STAFF REPORT ADDENDUM

SPECIAL PERMIT APPLICATION NO. SP 2009-SU-018

NEW VISION COMMUNITY CHURCH, INC.

Re: Special Permit SP2008-0303, New Vision Community Church
Plat Revised thru March 24, 2010

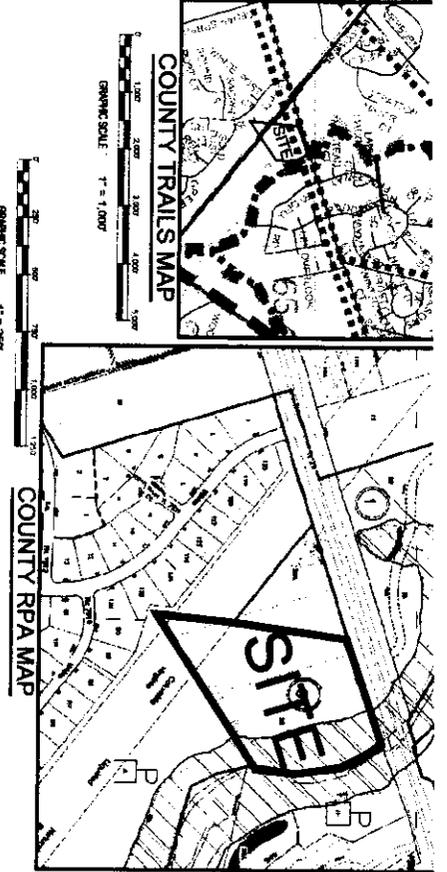
CONSIDER EXTENDING THE RIGHT TURN LANE TO MEET (CONT'D)

(CONT'D)

DECELERATION IF THE ENTIRE RUN OF FIBER OPTIC LOCATED IN THE VICINITY NEEDS TO BE RELOCATED DUE TO LACK OF "SLACK LINE". THIS IS TO BE COORDINATED WITH THE LAND DEVELOPMENT SECTION DURING THE PROGRESSION OF DESIGN & COORDINATION WITH UTILITY COMPANIES

SP 2008-0303
 SHEET 2 OF 8

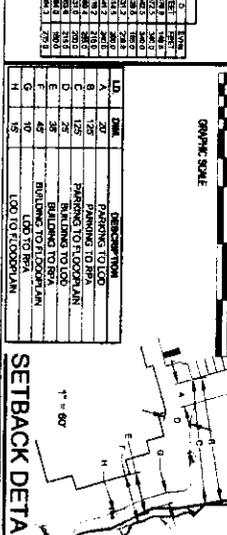
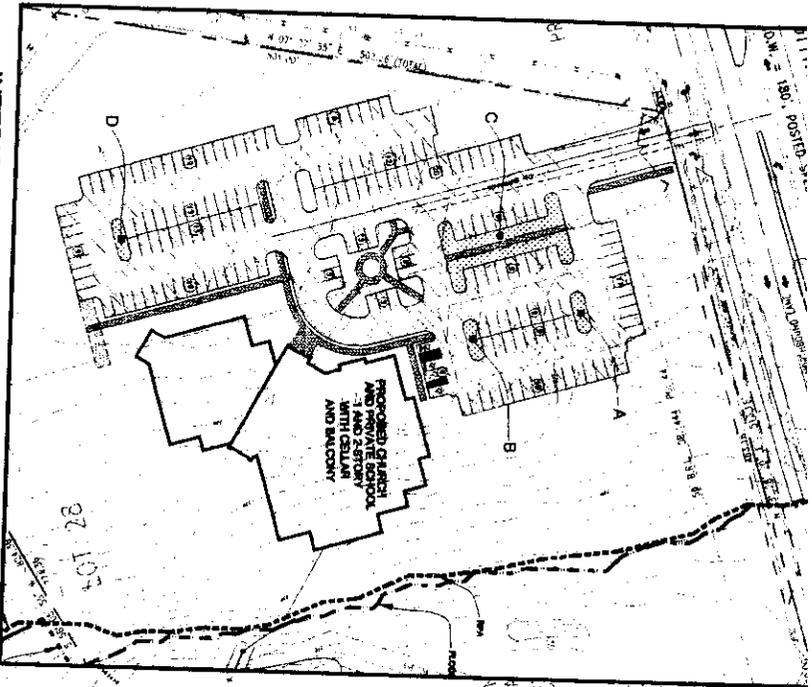
Sheet 2 of 8 entitled "Co. Maps and Site Tabulations" (Previously Sheet 2 of 6)

1. No changes were made to this sheet except as indicated above under the General heading since none of the VDOT agreements impacted the data shown here.

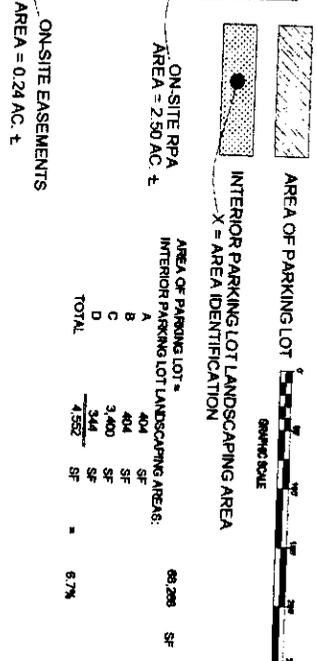
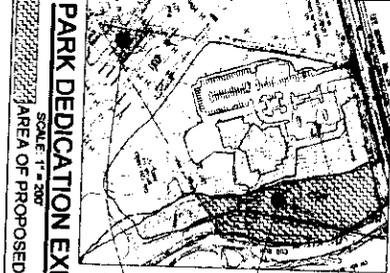
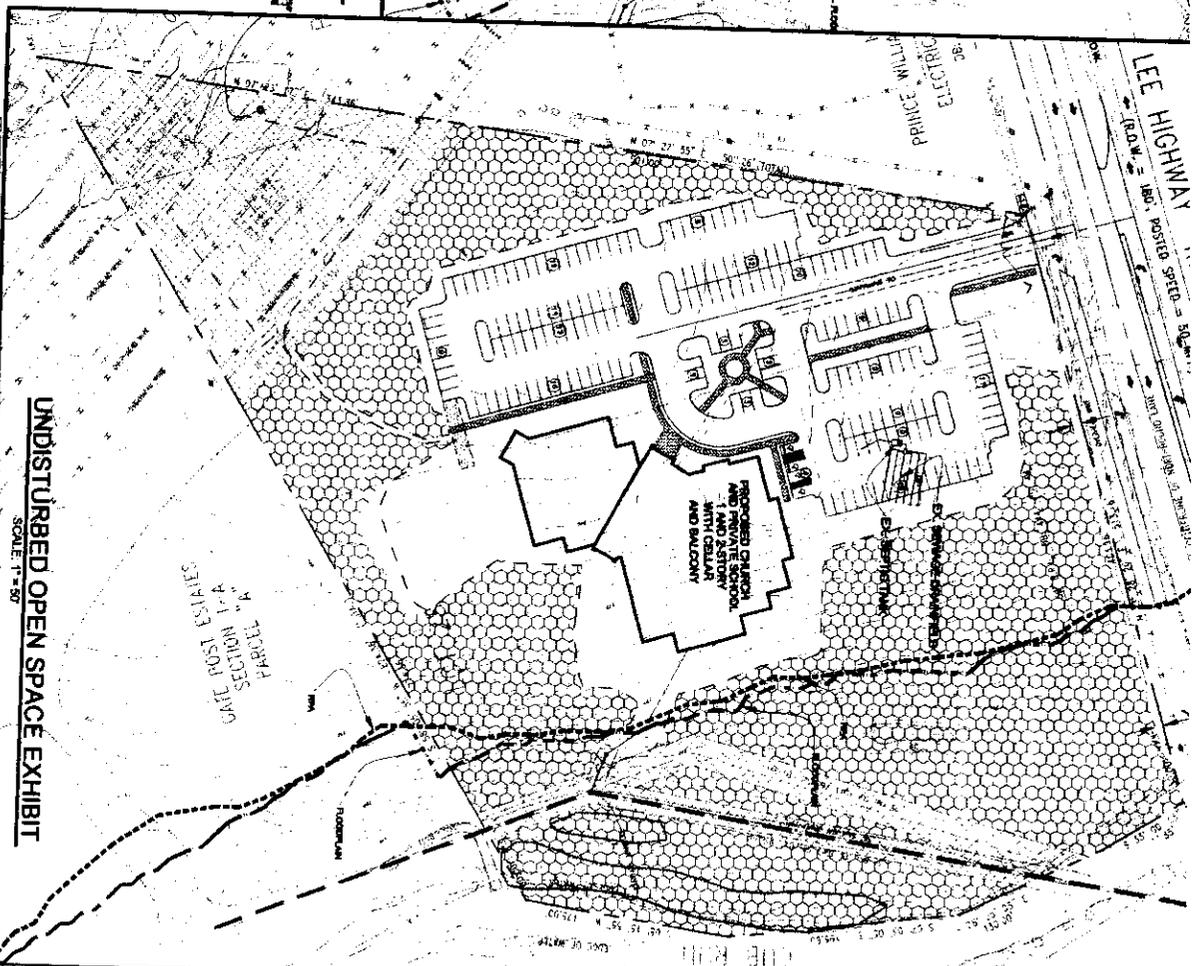
Sheet 6 of 8 entitled "Open Space & Parking Exhibits" (Previously Sheet 6 of 6)

1. Added the field location of the existing septic tank and drainfield on the site, as well as leaders and labels for these. This shows up on the Undisturbed Open Space Exhibit only. Also added the 10/6/09 date and note under Plan Status.
2. Added dimensions between the property line and the undisturbed area of 7' and 8' as previously discussed. This was also completed in October of 2009 but not submitted.
3. Revised the Route 29 improvements and entrance layout (within the VDOT ROW only) to comply with the changes requested and agreed upon during the waiver review. Please see the notes on Sheets 7 and 8 of this memo for additional detail on what was modified on Route 29. This shows up on all three of the exhibits on this sheet.
